REMARKS

Applicant : Vinay K. Awasthi
Serial No. : 09/753,083
Filed : December 28, 2000
Page : 16 of 16

Attorney's Docket No.: 10559-373001 / P10179

Amendments to the Drawings:

FIG. 2

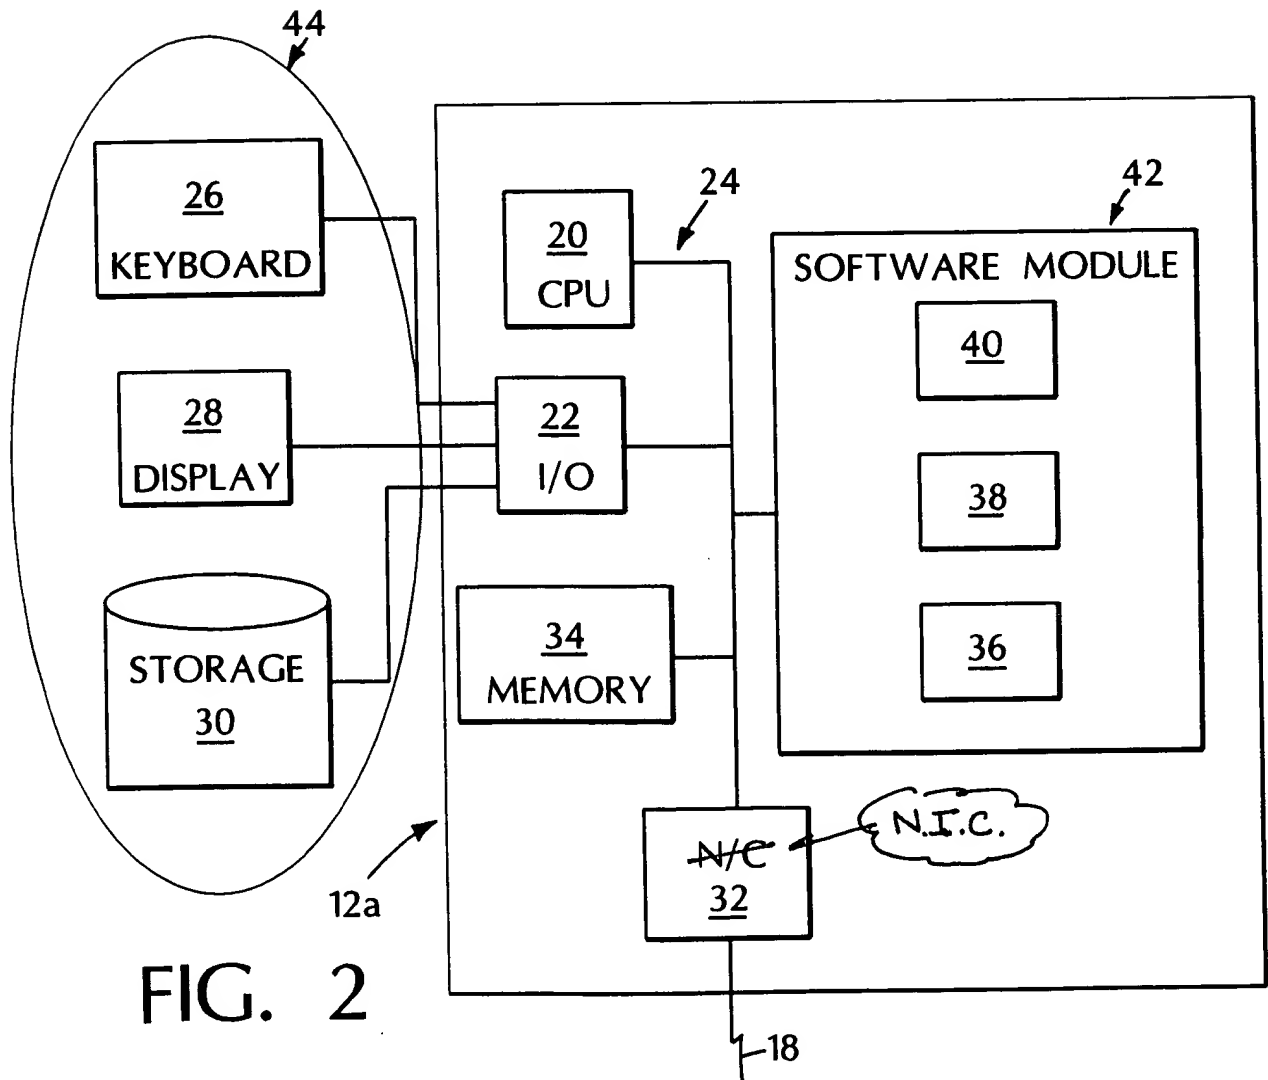
Fig. 2 was objected to because element 32 should be labeled “NIC,” not “N/C.” Fig. 5 was objected to because step 170 should read “Receive data packets from device.” Fig. 5 also was objected to because step 180 should read “Transfer Data Packets to Program.” Applicant has corrected each of these clerical errors. Two replacement sheets showing these corrections are attached.

In Figure 2, "N/C" in the box labeled 32 has been changed to "NIC."
